## CITY OF TORONTO DESIGN REVIEW PANEL MINUTES: MEETING 3– April 21, 2017

# 2442 – 2454 BLOOR ST WEST and 1-9 RIVERVIEW GARDENS

# YONGE- EGLINTON BUILT FORM STUDY

# 908-916 ST CLAIR AVE WEST

2 RIVERVIEW GARDENS - Current Revised Proposal

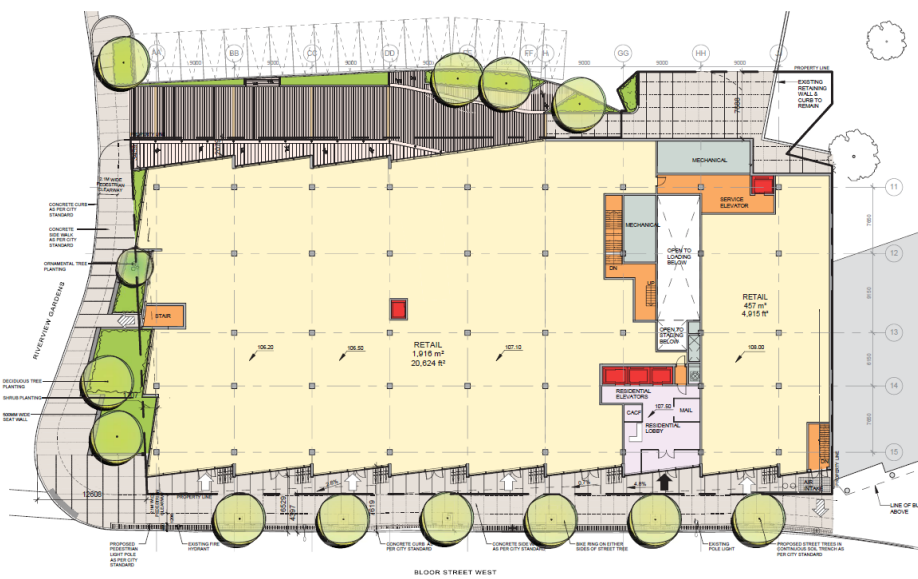
- "Stepping down the sawtooth articulation is dynamic and appropriate."
- "There have been some lovely advances in the work."
- "...impressed with changes...like the simplification and commend you on the simple strong move"
- The stepping of the façade was also noted to be an "intriguing way" to respond to the curve of Bloor St

-remove the protruding balconies and provide inset ones as per the first design, "the previous one without protruding balconies was more successful. It's the underside of balconies that make it a busy façade".

A more vertical expression was encouraged to be looked at on the east façade as per the previous scheme, by several Panel members, to respond to the view terminus. "In this view there is just a flanking wall...the return is very big and bulky. Look at if you don't return and have a more vertical expression."

a. Transition to the north: Several Panel members advised more transition be provided down to the neighbourhood on Riverview. Due to the building being on a hill when seen from Riverview Gardens, it appears more substantial, and a Panel member noted that there should therefore be more transition at the rear.

## C2. REDPATH PARK STREET LOOP ELEVATION ALONG ROEHAMPTON AVENUE LOOKING SOUTH EMERGING DIRECTION (2041)

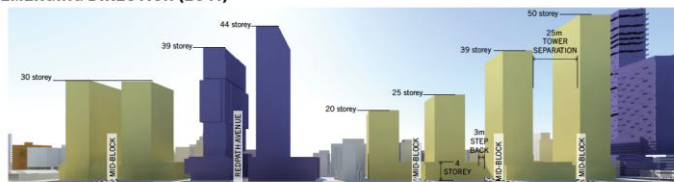
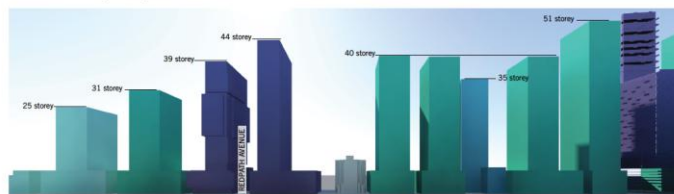
The diagrams comparing the status quo and emerging directions were commended by many Panel members. "The diagrams are brilliant...The power and strength of studies allow us to imagine how the public realm and liveability of the area will be built out." In comparing the proposed directions versus the status quo, panel members were supportive of the improved liveability conditions:  
-solar access improvements were commended  
-the improvements in skyviews were noted to be good in that they provide significantly more sky view than the status quo

It was also observed that the 25m separation between towers is uniformly shown in the drawings when it is actually a minimum dimension in existing guidelines. The consistent use of this minimum separation in the diagrams contributes to the issue and should be remedied.

**CHERRY SQUARE PLAN**  
Adjusted retail, added trees, added freestanding chairs & raised brick pavement (for increased soil depth & stage)

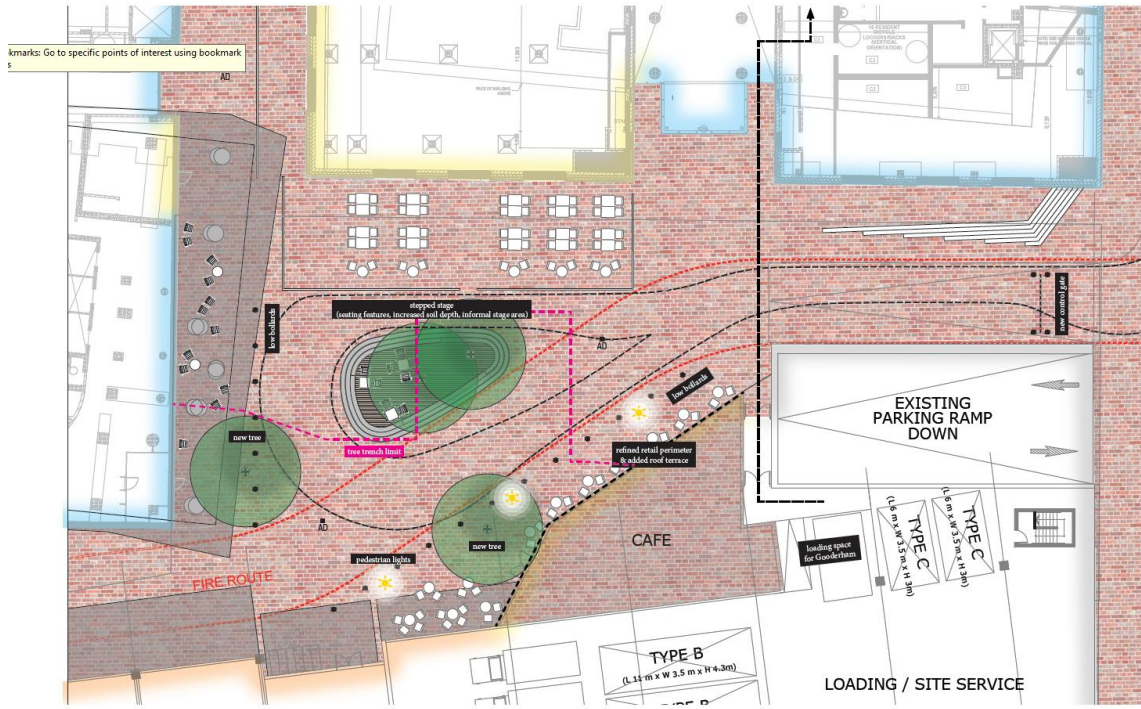
While recognizing the constraints of soil depth, many members advocated for as much planting and greenery as possible. A suggestion was to add a strip of planting on the north wall of garage will green the wall and help mitigate the "relentless brick everywhere".

Several Panel members were appreciative of the control in the design, "love its simplicity and lack of messiness – it's not that big of a space... The ground plane itself fills spaces. It's beautiful."

"However several other members advocated for "more messiness" in the design. A Panel member advised, "Everything should spill more and not be so controlled... The solution is correct but it just would be nicer if there was a little more animation."

Panel members advised as much liveliness as possible. The precedent example of the St-Emilion Square in France, was appreciated and a Panel member advised a similar quality of casualness, "Even if the chair is in the fire route just move the chair."
